Recall Campaign 16V-071: Driver's Front Air Bag Module E82 E88 E90 E91 E92 E93

This Service Information bulletin supersedes SI B65 16 16 dated **March 2017**.

Whats new:

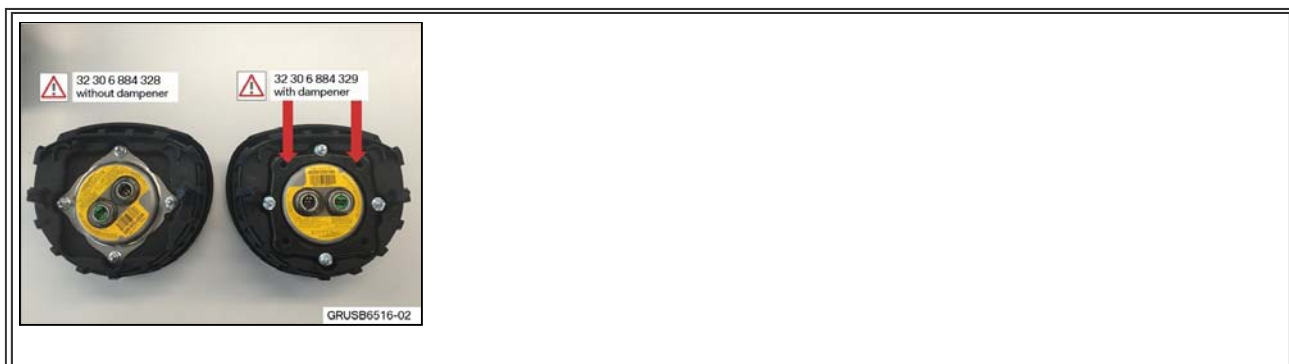
UPDATE ! Note: Only request and invoice the applicable part number specified and listed in this Service Information bulletin.

UPDATE ! Performing a part number look-up in ETK by VIN or model will result with the wrong part(s) being invoiced and installed.

Note: **Original part coming out of the vehicle may not match the replacement part. This**

applies to vehicles originally equipped with or without a dampener.

It is important that the correct airbag module is installed. Only install the air bag module

based on the model and engine variant listed in the parts information. Do not mix up the two parts. Refer to the photos above. Printing this SI in color will make it easier to see the difference in the parts.

| <p>UPDATE! 32 30 6 884 313 (Desiccated)</p> | <p>airbag module driver's side base without vibration absorber (for all E82, E88, E91 and E92) or (for all E90 and E93 with the exception of the engines listed for part number 32 30 6 884 329 below)</p> | |
| <p>UPDATE! 32 30 6 884 314 (Desiccated)</p> | <p>airbag module driver's side with a vibration absorber (on E90 only with engine S65 or M57Y) and (on E93 only with engine S65 or N54T or N55)</p> | 1 |
